Product Change Notice (PCN)

PCN Number: PCN-0451169R-01

Product(s) Affected: *PJ-043H*

PREVIOUS CUI DEVICES DETAIL / IMAGE	NEW CUI DEVICES DETAIL / IMAGE

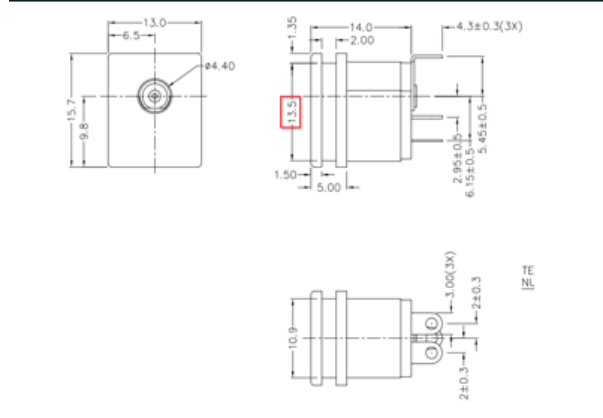
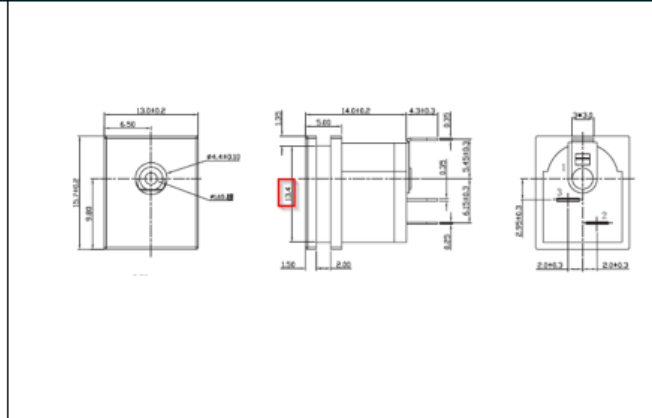
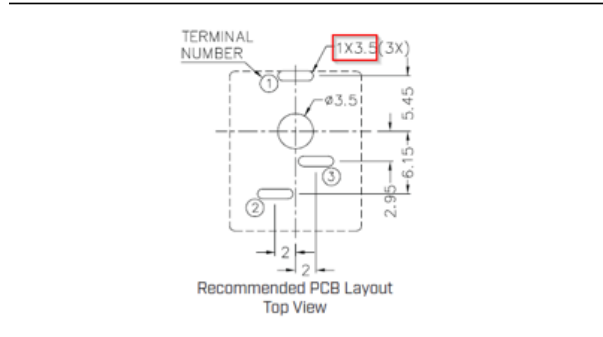
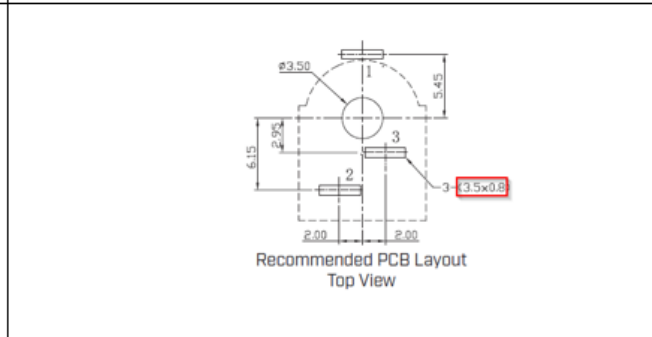
Description of Change: *Minor Housing and footprint differences. Material Change on the housing and terminals. See image Below*

PREVIOUS CUI DEVICES DETAIL / IMAGE			NEW CUI DEVICES DETAIL / IMAGE		
	MATERIAL	PLATING			
center pin	copper	nickel	DESCRIPTION	MATERIAL	PLATING/COLOR
terminal 1	brass	silver	center pin	brass	nickel
terminal 2	copper alloy	silver	terminal 1	brass t=0.35	silver
terminal 3	brass	silver	terminal 2	bronze t=0.25	silver
			terminal 3	brass t=0.35	silver

MATING PLUG
Jack Insertion Depth: 9.50 mm

MATING PLUG
Jack Insertion Depth: 9.0 mm
